Item #6
MCPB
3/6/04MEMORANDUM

DATE: April 30, 2002
TO: Montgomery County Planning Board
VIA: Rick Hawthorn, Chief
 Michael Ma, Supervisor
 Development Review Division
FROM: Wynn E. Withans *WW*
 Planning Department Staff
 (301) 495-4584

REVIEW TYPE: Site Plan Review
APPLYING FOR: 650 square feet of covered walkway and path and 81 parking parking spaces
PROJECT NAME: Potomac Ridge Behavior Health
CASE #: 8-04008
REVIEW BASIS: Sec. 59-D-3, M. C. Zoning Ordinance

Staff recommends approval of site plan 8-04008 with the following conditions to be met prior to signature set release:

PLAN - PARKING + SIDEWALK

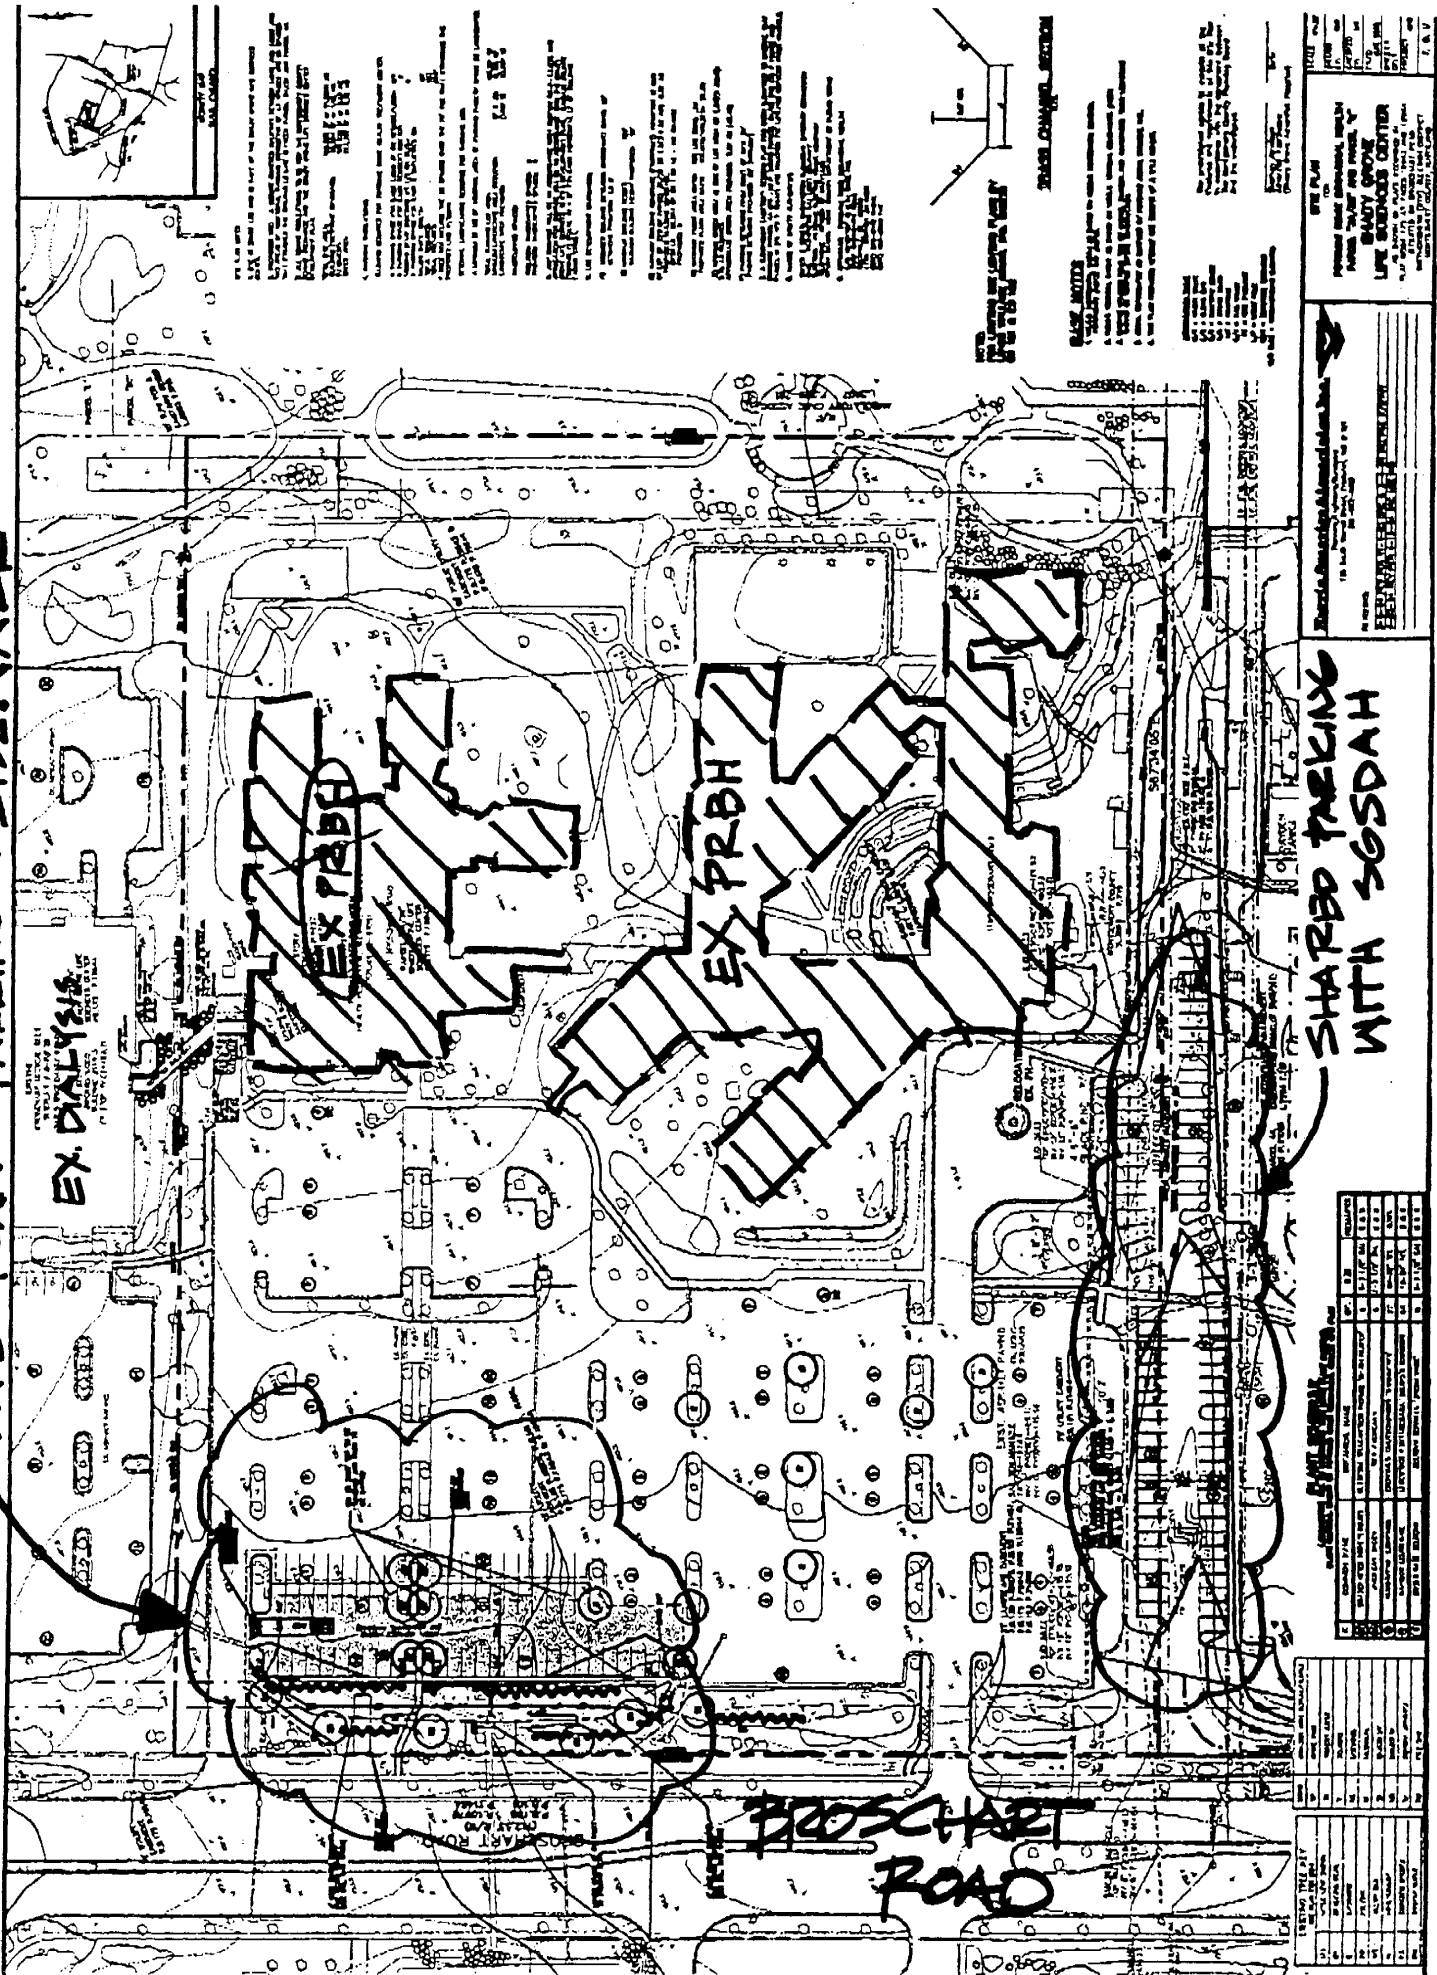
The stormwater management approval is linked with the SWM approval for Site Plan #8-99024a Shady Grove Adventist Hospital.
 - c. Landscaping and Lighting

The landscaping provides enhancement to pedestrian areas and to the parking lot areas. The landscaping preserves some of the existing trees and parking lot screening, giving the new proposal a well integrated look.

The lighting plan for the proposal, once revised to conform to IESNA standards, will give adequate lighting for all pedestrian areas. The final plan will reduce light levels so to not create off site impacts such as glare or excessive nightglow.
 - d. Recreation

The vehicular circulation pattern has been improved with the proposal, increasing the efficiency of the parking lot. The pedestrian system is thoroughly connected through the site providing safe pedestrian connections with a system of cross walks and sidewalks.
4. *Each structure and use is compatible with other uses and other Site Plans and with existing and proposed adjacent development.*
